CITY OF WESTMINSTER			
PLANNING APPLICATIONS COMMITTEE	Date 18 October 2016	Classification For General Release	
Report of Director of Planning		Ward(s) involved West End	
Subject of Report	29-35 Rathbone Street, London, W1T 1NJ,		
Proposal	Alterations and extensions at basement, rear and roof level and partial change of use to provide a gym (Class D2) at basement, restaurant (Class A3) at ground floor and offices (Class B1) at first to third floor and fourth floor mezzanine with terraces, and installation of plant at third floor		
Agent	Mr Claire Treanor		
On behalf of	ISA Holdings Ltd		
Registered Number	16/02884/FULL	Date amended/ completed	7 April 2016
Date Application Received	31 March 2016		
Historic Building Grade	Unlisted		
Conservation Area	Charlotte Street, West

Refuse permission – detailed design

91 REVISED REAR ELEVATION
A210 SCALE AT 1:100

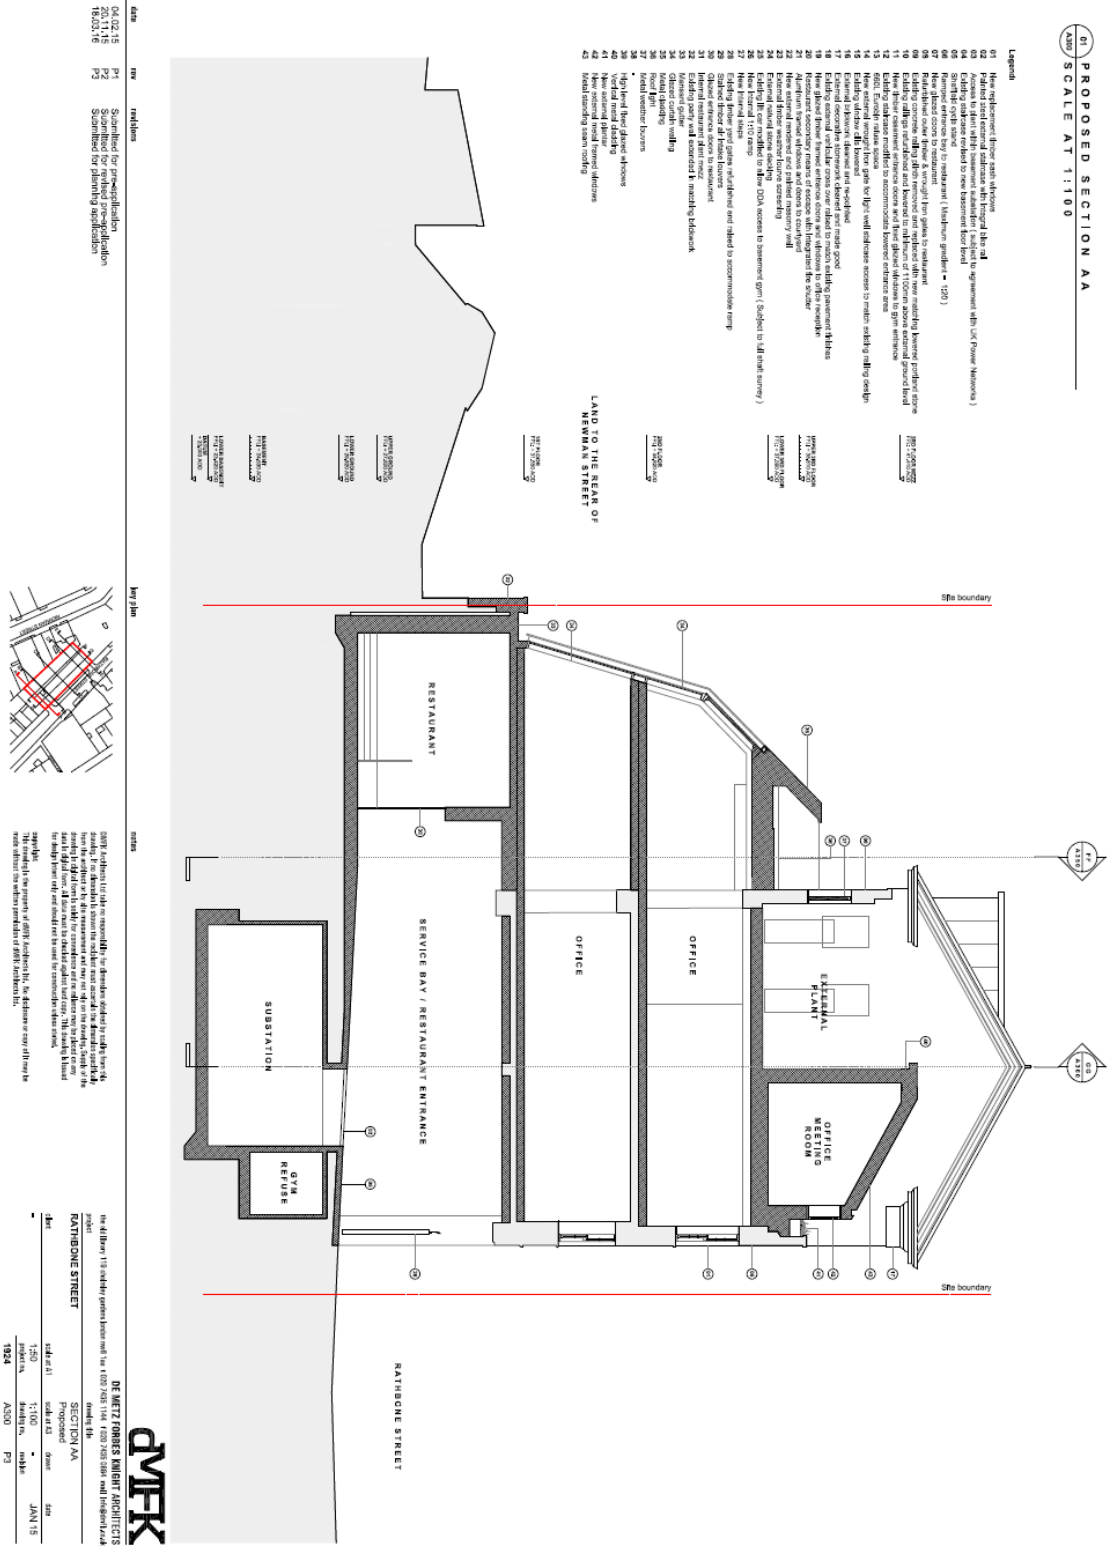
Whilst not exactly symmetrical at the rear, the overall balance of the composition must be maintained. However, the rear extension is a dramatic off-centre addition. It is so large and badly positioned that it would severely compromise the architectural quality of the rear facade of the existing building. The extensions at third floor level, on either side of the central pavilion, would detract from the appearance of the building by reducing the prominence of the primary feature of the street facade.

Whilst there is no objection, in principle, to altering and extending the building at the rear, the extension must be symmetrical and any high level alterations at the front must be subordinate to the building and sympathetic to its detailed design.

The benefits of the scheme in terms of removing the conservatory are comprehensively outweighed by the harm caused the building's appearance by the proposed extensions at the rear and at third floor level. This is contrary to UDP policies DES 1, DES 5, DES 6 and DES 9, and the City Councils 'Development and Demolition in Conservation Areas' supplementary planning guidance.

61 PROPOSED FRONT ELEVATION
A00 SCALE AT 1:150

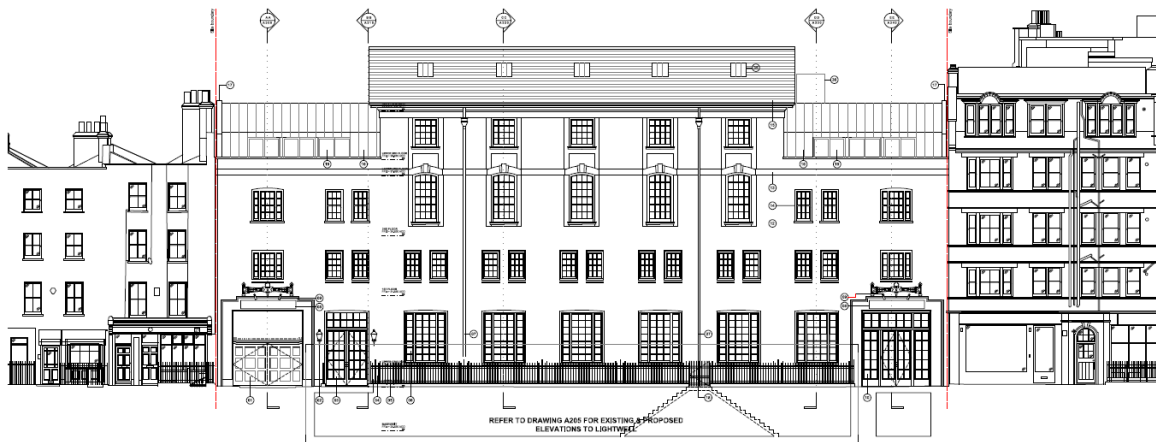
New and altered basement windows, increasing the size of the ground floor windows facing the street by lowering their sills, and reducing the height of the railings' plinth are acceptable. However, most of the proposed alterations are not acceptable.
